AENC-NG-CNS-REP-0343

Norwich to Tilbury

Document: 8.11 Approach to Scenarios - Tracked
Changes Version

Final Issue B

Table 2.4 Flying Trade Group and Crown Quarry east and west of the A12 (Sections C and D)

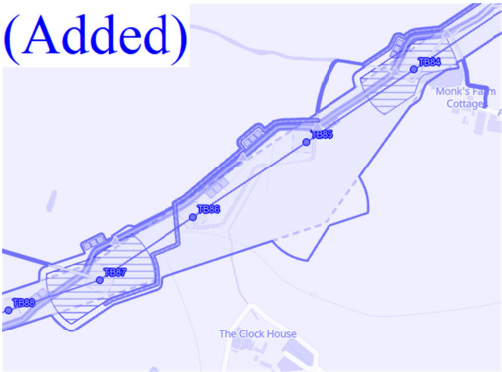
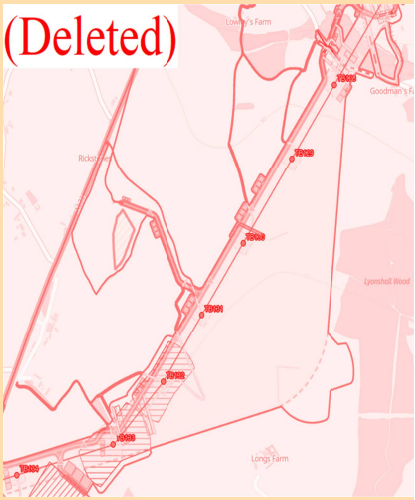
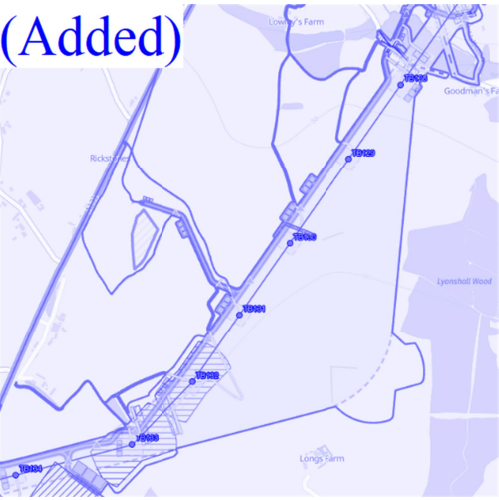
Type	Description (Text & Images from ES Chapter 4)	Relevant Stakeholders	Current Status	Securing Mechanism	Decision
OHL (Del) 	(Add)  <p>Figure 4.1: Proposed Project Design (document reference 6.4.F1) and Figure 4.2: Proposed Project Design – Permanent Features (document reference 6.4.F2) shows widened Order Limits between TB18 and TB22. The LoD and Order Limits have been widened between TB18 and TB22 as there are a number of planning applications associated with the Flying Trade Group and Crown Quarry developments adjacent to the A12. <u>Scenario B is an arrangement for the OHL to pass to the north of the FTG warehouse.</u></p>	Flying Trade Group (FTG) Crown Quarry	Preference to progress with Scenario B – overhead line alignment to the North of the consented warehouse with access sharing main warehouse access. <u>This would address concerns from FTG and landowners, and businesses south of Wick Lane. Now have sight of FTG access and through discussion have established that amended access arrangements meet traffic standards, Have also agreed</u>	Assuming <u>In principle agreement has been reached, we anticipate securing mechanism will be through:</u> <ul style="list-style-type: none"> • <u>Statement of Common Ground or Heads of Terms Agreement with Flying Trade Group Quarry</u> • <u>Code of Construction Practice</u> • <u>Crown Quarry have established a proposed way of working that maintains Applicant access and between Applicant and Quarry operator has minimised</u> 	<u>Decision to proceed with Scenario B subject to final sight of Access adjustments to confirm meet highway safety. Flexibility required whilst SoCG and terms are finalised. Change is the reposition within the Order Limits of the overhead line and access route to pass to the north of the FTG warehouse.</u>

Type	Description (Text & Images from ES Chapter 4)	Relevant Stakeholders	Current Status	Securing Mechanism	Decision
			<u>positioning of pylons with FTG.</u>	<u>the extent of sterilisation. SOCG to be secured with operator.</u>

Table 2.8 Crest Nicholson housing development south of the A127 (Section G)

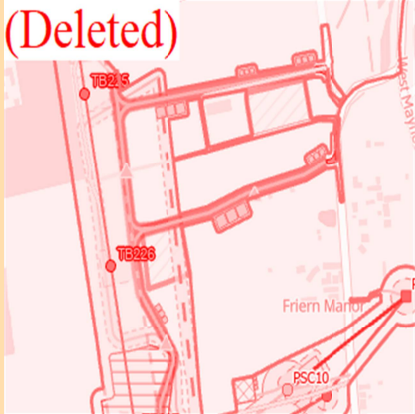
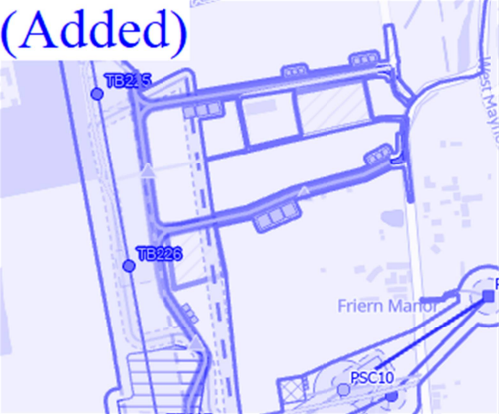
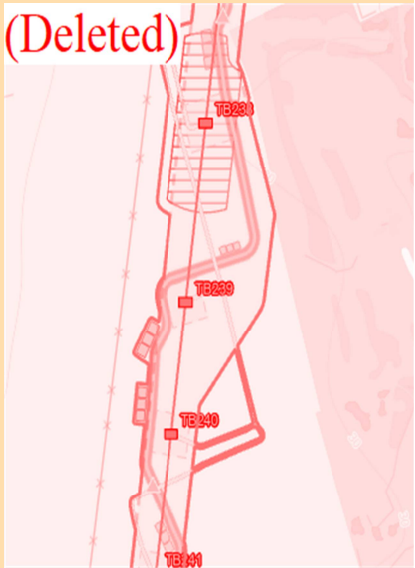
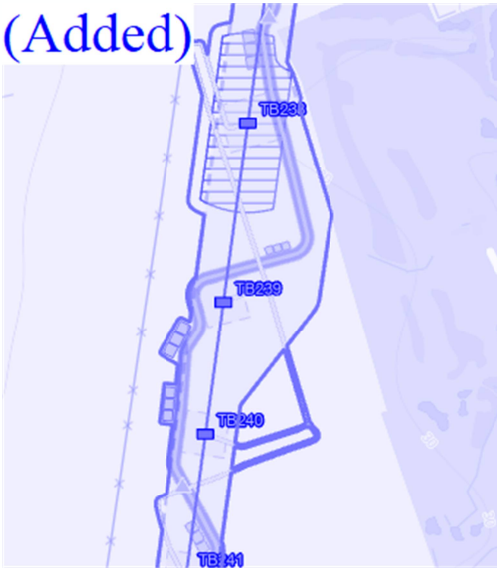
Type	Description (Text & Images from ES Chapter 4)	Relevant Stakeholders	Current Status	Securing Mechanisms	Decision
Access	<div style="display: flex; justify-content: space-around;"> <div style="text-align: center;"> <p>(Deleted)</p>  </div> <div style="text-align: center;"> <p>(Added)</p>  </div> </div> <p>Figure 4.1: Proposed Project Design (document reference 6.4.F1) shows two haul roads/construction access arrangements within the Order Limits between TB225 and TB226.</p> <p>Two haul roads are presented to provide an alternative haul road should the Crest Nicholson housing development progress.</p>	Crest Nicholson	<p>Northern scenario to be withdrawn upon submission of a planning application for the Crest Nicholson scheme.</p> <p>There is already an agreement in place with the housebuilder.</p>	<p>Assuming agreement reached, we anticipate securing mechanism will be through:</p> <ul style="list-style-type: none"> • Statement of Common Ground • Code of Construction Practice 	<p>Decision to be made once the third party planning application has been submitted. Outcome awaited.</p>

Table 2.9 British Pipeline Agency (BPA) pipeline crossing west of Langdon Hills Golf and Country Club (Section H)

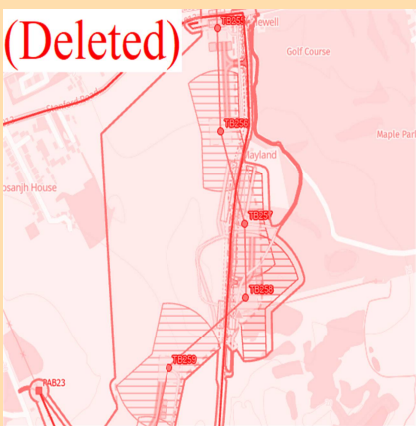
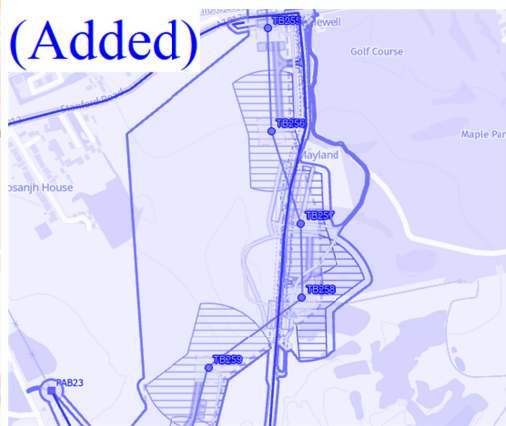
Type	Description (Text & Images from ES Chapter 4)	Relevant Stakeholders	Current Status	Securing Mechanism	Decision
Pipeline	<div style="display: flex; justify-content: space-around;"> <div style="text-align: center;">  <p>(Deleted)</p> </div> <div style="text-align: center;">  <p>(Added)</p> </div> </div> <p>Figure 4.1: Proposed Project Design (document reference 6.4.F1) and Figure 4.2: Proposed Project Design – Permanent Features (document reference 6.4.F2) shows an overhead line alignment between TB238 and TB240.</p> <p>The LoD and Order Limits have been widened between TB238 and TB240 to allow flexibility to enable an alternative alignment with more angles to facilitate a more</p>	BPA (UKOP)	<p>Change application being progressed in order to facilitate works and land rights required for pipeline mitigation measures.</p> <p>Expected that the proposed Protective Provisions and/or Side Agreement would regulate the final design and routing of the OHL and related mitigation.</p> <p>No expected change to be made – subject to proposed Change Application 1 being accepted.</p>	Not relevant	<p>No further change required.</p> <p>No change proposed to be made, this is subject to proposed change application 1 being accepted. The proposed change application is due to be submitted March 2026, with a decision expected by April/May 2026. Change Application was accepted for examination on 30 April 2026 and we</p>

Type	Description (Text & Images from ES Chapter 4)	Relevant Stakeholders	Current Status	Securing Mechanism	Decision
					await the decision

Table 2.11 Lower Thames Crossing (LTC) south of the proposed new Tilbury North Substation (Section H)

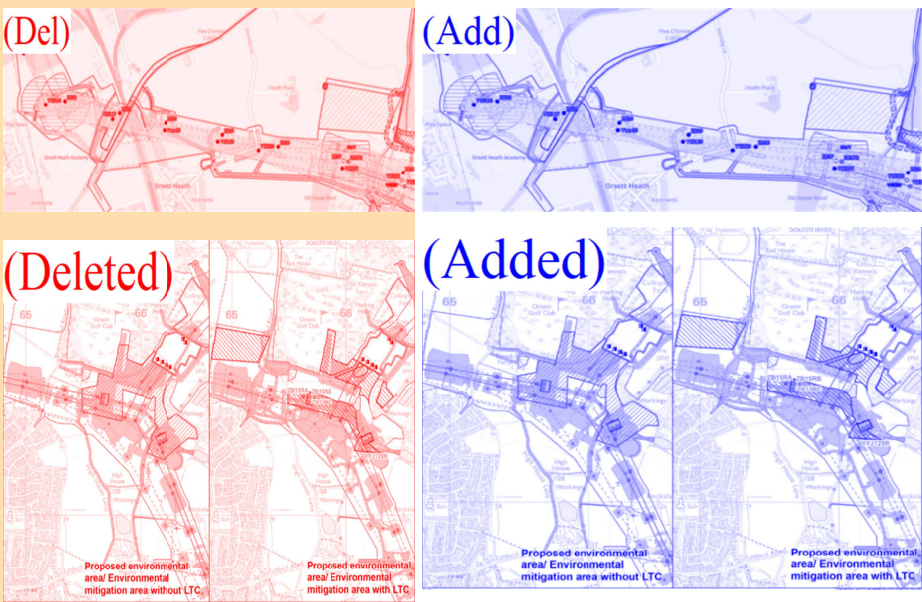
Type	Description (Text & Images from ES Chapter 4)	Relevant Stakeholders	Current Status	Securing Mechanism	Decision
OHL		<p>LTC Bleer-Homes Thurrock Council Chapel Farm Development Proposals</p>	<p>As per the letter submitted to PINS on 9th February, amendments to LTC diversion requirements and adoption of scenario B for connecting Tilbury North Substation to the YYJ overhead cable line removes the need for flexibility covered by this scenario.</p>	<p>Assuming agreement reached, we anticipate securing mechanism will be through:</p> <ul style="list-style-type: none"> • Development Consent Order Schedule 1 • Updated, Works and Lands Plans • Side Agreement with LTC 	<p>Adoption of Scenario B. The Draft DCO submitted as Deadline 2 [REP2-004] includes necessary revisions to Schedule 1. Works Plans and Lands Plans are expected to be updated for Deadline 5. 2.3 Works Plan - Section H (Revision B); 8.15.1 Proposed Project Design - Scenario 18 (Table 2.18) (Revision A); 8.15.2 Proposed Project Design - Permanent Features - Scenario B (Table</p>

Figure 4.1: Proposed Project Design (document reference 6.4.F1) and Figure 4.2: Proposed Project Design – Permanent Features (document reference 6.4.F2) shows temporary and permanent works to existing overhead line infrastructure (YYJ and ZB) to the south of the A13 and A1089 junction in the proximity of Heath Road. The LoD and Order Limits have been widened at this location to allow a change to the design should the

Type	Description (Text & Images from ES Chapter 4)	Relevant Stakeholders	Current Status	Securing Mechanism	Decision
	<p>ongoing coordination identify a change is required <u>as a result of LTC</u>. Should LTC not be progressed, <u>or</u> an alternative Environmental Area is also proposed <u>design be progressed by LTC</u> then land to the west of heath road may not be needed. There is an <u>inter-relationship with scenario 18 which relates to alternative means of connection to the south of the substation where A is connecting to the existing line (referred to as the YYJ) as overhead line and B as underground cable.</u></p>				<p><u>2.18) (Revision A); and 8.15.3 Class of Rights - Plans Section H - Scenario B (Table 2.18) (Revision A) will be submitted at Deadline 4. All other documents relevant to Scenario B will be submitted at Deadline 5.</u></p>

Table 2.13 Black Brook north of Langham (Section C)

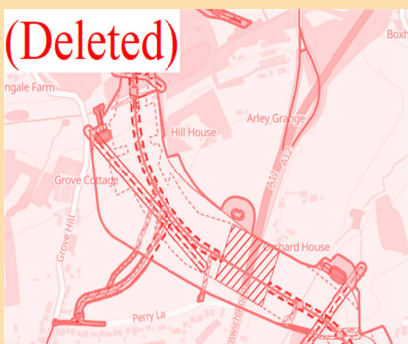
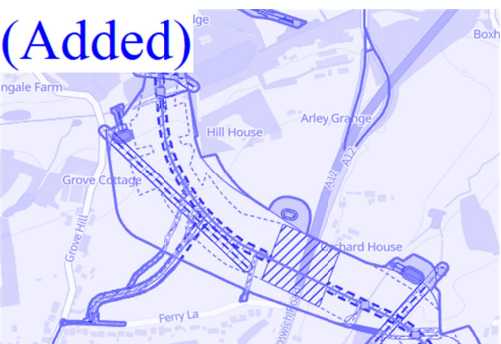
Type	Description (Text & Images from ES Chapter 4)	Relevant Stakeholders	Current Status	Securing Mechanism	Decision
UGC	<div style="display: flex; justify-content: space-around;"> <div style="text-align: center;"> <p>(Deleted)</p>  </div> <div style="text-align: center;"> <p>(Added)</p>  </div> </div> <p>Figure 4.1: Proposed Project Design (document reference 6.4.F1) and Figure 4.2: Proposed Project Design – Permanent Features (document reference 6.4.F2) shows an underground cable alignment to the south of Black Brook.</p> <p>The LoD and Order Limits have been widened slightly to the west of the A12 and south of Black Brook to allow for flexibility of routing individual cable trenches in the vicinity of existing United Kingdom Power Network (UKPN) underground cables.</p>	TBC	<p>No change required. Construction of the project will respond to constraints posed by third party apparatus.</p> <p>Any interactions with existing apparatus would be regulated through existing Protective Provisions included in the draft DCO.</p>	Not relevant given reason for wider limits	<p>Retaining flexibility into delivery <u>to respond to detailed ground investigation results and their potential to modify 400kV cable trench alignment.</u></p>

Table 2.14 Great Horkesley south of School Lane (west of Great Horkesley) (Section D)

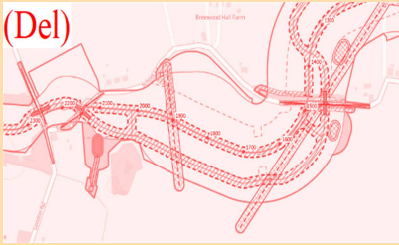
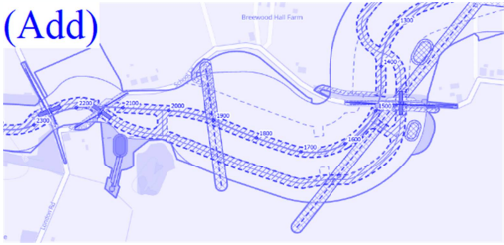
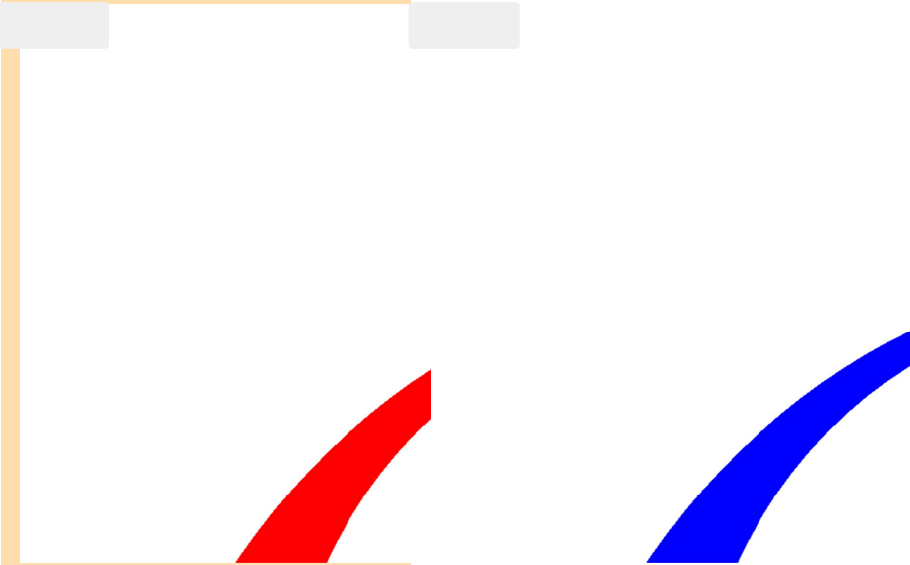
Type	Description (Text & Images from ES Chapter 4)	Relevant Stakeholders	Current Status	Securing Mechanism	Decision
UGC	<div style="display: flex; justify-content: space-around;"> <div style="text-align: center;">  <p>(Del)</p> </div> <div style="text-align: center;">  <p>(Add)</p> </div> </div> <p>Figure 4.1: Proposed Project Design (document reference 6.4.F1) shows widened LoD and Order Limits to the south of School Lane (west of Great Horkesley) to allow for a wider temporary construction area if required as the underground cable alignment to the west is heavily constrained.</p>	TBC	<p>No change required. Construction of the project will respond to constraints posed by third party apparatus. Any interactions with existing apparatus would be regulated through existing Protective Provisions included in the draft DCO.</p>	Not relevant given reason for wider limits	<p>Retaining flexibility into delivery <u>to potentially allow the adoption of different cable installation methods which may or may not require material to be temporarily stored along the construction corridor away from the area where construction width is heavily constrained.</u></p>

Table 2.16 Thurrock Airfield and Low Heights west of Langdon Hills Golf and Country Club (Section H)

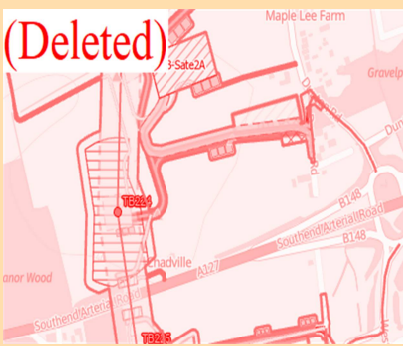
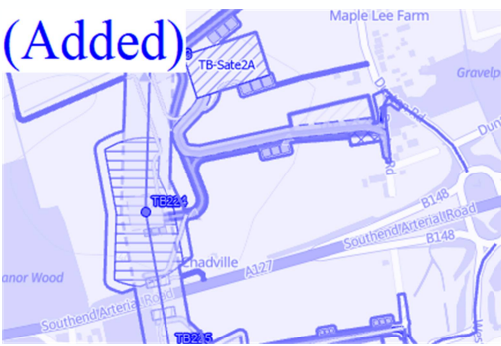
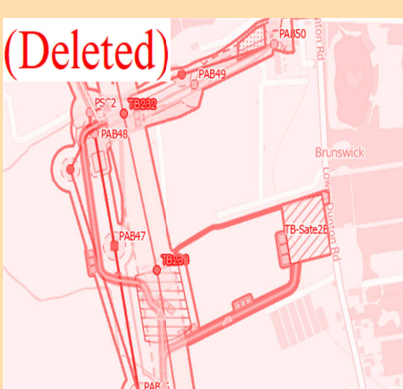
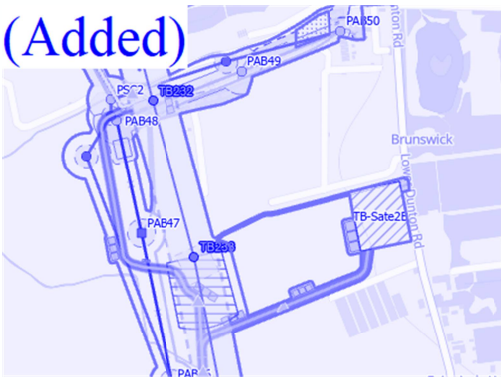
Type	Description (Text & Images from ES Chapter 4)	Relevant Stakeholders	Current Status	Securing Mechanism	Decision
OHL	<div style="display: flex; justify-content: space-around;"> <div style="text-align: center;"> <p>(Deleted)</p>  </div> <div style="text-align: center;"> <p>(Added)</p>  </div> </div>	TBC	<p>Pylon height remains dependent on the planning status of Thurrock Airfield and a successful appeal against refusal of housing proposals for the site.</p> <p>Working assumption that the Airfield remains in use. As of April 2026, the appeal was dismissed and the applicant assumes the airfield will continue to operate and therefore low</p>	<p>Assuming <u>dismissal of appeal and agreement being reached with the airfield</u>, we anticipate securing mechanism will be through:</p> <ul style="list-style-type: none"> <u>SOCG with airfield operator</u> Permitted under Article 5 (1)(b)(i) Work Plans (Table of Parameters) Code of Construction Practice 	<p>No change for present purposes. Retain both scenarios but commitment to progress with low height lattice pylons unless airfield operations cease prior to construction.</p> <p><u>to preferred design following the dismissal of the appeal and the applicant is proceeding on the basis of the continued operation of the airfield, which</u></p>

Figure 4.1: Proposed Project Design (document reference 6.4.F1) and Figure 4.2: Proposed Project Design – Permanent Features (document reference 6.4.F2) show an alignment between TB238 and TB243. Low height pylons are proposed between TB238 and TB243 to cater for Thurrock

Type	Description (Text & Images from ES Chapter 4)	Relevant Stakeholders	Current Status	Securing Mechanism	Decision
	Airfield. However, should a housing development be brought forwards at Thurrock Airfield and/or the airfield be closed, low height pylons would not be required and standard lattice pylons would be installed instead.		<u>height pylons retained as the design</u>		<u>requires the design to include low height pylons between TB238 and TB243.</u>
